Delegated Report		Analysis sheet		Expiry Date:	13/03/20	023	
		N/A / attac	hed	Consultation Expiry Date:	02/04/20	023	
Officer	Application Nu	Application Number(s)					
Miriam Baptist			2023/0208/P				
Application Address			Drawing Numb	Drawing Numbers			
14 Well Road London NW3 1LH			Refer to Draft D	Refer to Draft Decision Notice			
PO 3/4 Area Tea	m Signature	e C&UD	Authorised Off	Authorised Officer Signature			
Proposal(s)							
External alterations including installation of stone cladding to front and part of side elevations with roof-coping, a rooflight above garage, alterations to fenestration at rear ground floor level, new boundary treatment to frontage and landscaping works.							
Recommendation(s):	Refuse Planning Permission						
Application Type:	Householder Application						
Conditions or Reasons for Refusal:	Refer to Draft Decision Notice						
Informatives:							
Consultations

#### 1 Proposal

Figure A (above): Front Elevation showing placement of cladding units and coping

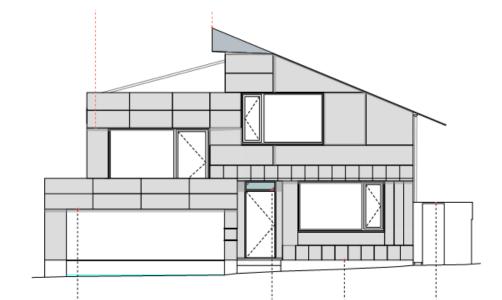
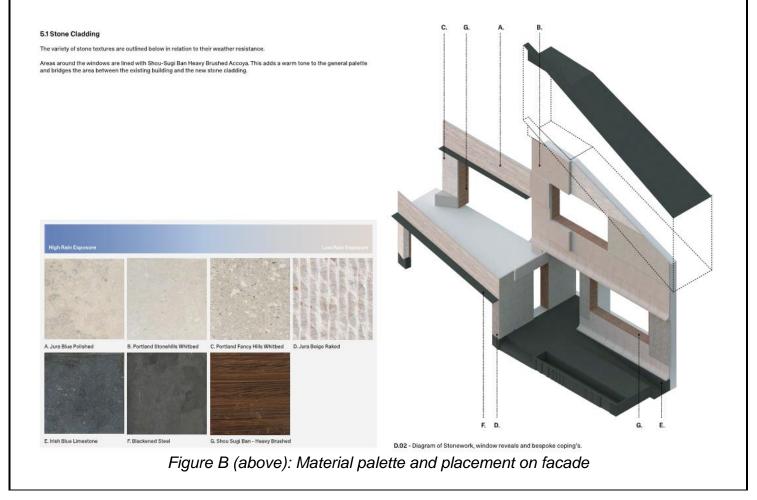
- 3.11 The existing building does not contribute positively to the character and appearance of the conservation area but is neutral; the fact that it is covered in a uniform render with a low boundary wall means it sits in the street with a degree of visual quietness.
- 3.12 There is no comparable stone cladding anywhere else in the road, and the prevailing materials are overwhelmingly brick and timber, as they tend to be on residential streets within the Hampstead Conservation Area more generally. While there is also very little render in the street beyond the subject site, render is noted as being a complementary material and often found in a Victorian suburb, which is the chief character of the street. The proposed alterations would result in a variety of stone claddings which are visually busy and draw more attention to a property which

is already at odds with the positive elements of the existing streetscene (chiefly the c.19th properties).

- 3.13 Although it is noted that nearby No 21 has an in-situ concrete/reconstituted stone finish, it is not considered a comparable precedent. No 21 is a standalone house of modern design and set back from the street behind a tall traditional brick wall, while No 14 Well Road is in a prominent position on the street (unlike other properties the garage comes right up to the pavement) in very close proximity to neighbouring properties. The adjacent c.19<sup>th</sup> properties at Nos 5-13 are a group of positive contributors. Although the application site is already contrasting in terms of materiality the current white render is considered to be plain and simple, not drawing any undue attention to itself.

- 3.14 As part of the façade works new coping is also proposed. The coping is presumably functional but also adds height to the property's front gable. Although the coping is not objected to as such, it is noted that the pinnacle feature does contribute to the overall cumulative effect of making the property more prominent on the street.

Figure C (above): Proposed stone cladding, new coping and high front boundary treatment

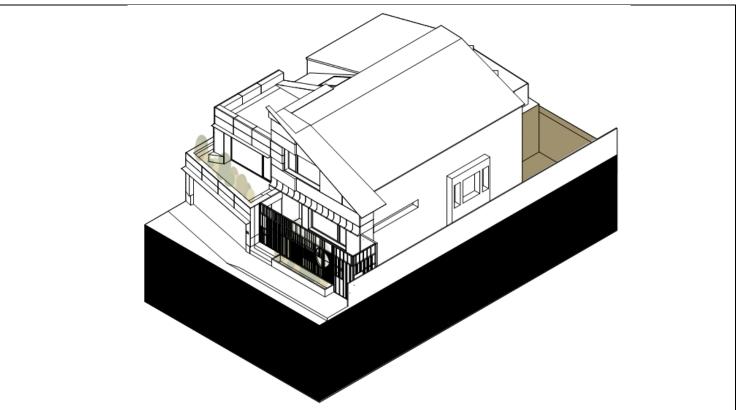
- 3.17 The design put forward for a new boundary is high, defensive, highly contemporary and some representations provided give it a cage-like appearance from the street. The proposed boundary appears to have Japanese architectural references and would be made of charred timber and blackened steel sat behind a low Irish blue limestone planter.

- 3.18 Although there are high boundary treatments to the west of the site, these are traditional garden wooden fences with hedges behind/above. While the application site's garage sits beside the higher garden fences to the west, the part-width garden with low-rise boundary is sympathetic and aligned in terms of height to the traditional boundary treatments of the c.21<sup>st</sup> houses on the other side.

- 3.19 Neither the proposed boundary changes nor proposed façade works, are considered contextual or sympathetic to the surrounding conservation area.
- 3.20 The landscaping alterations proposed to the side passage are not opposed in principle and would not be highly visible from the street. There is no objection as such to the additional door giving access to the garage, the rooflight over the garage, the new bin store or the new glazed sliding doors to the rear of the site improving garden access. It is rather the impact of the façade works and boundary treatment on the streetscape and wider conservation area that is considered of concern.
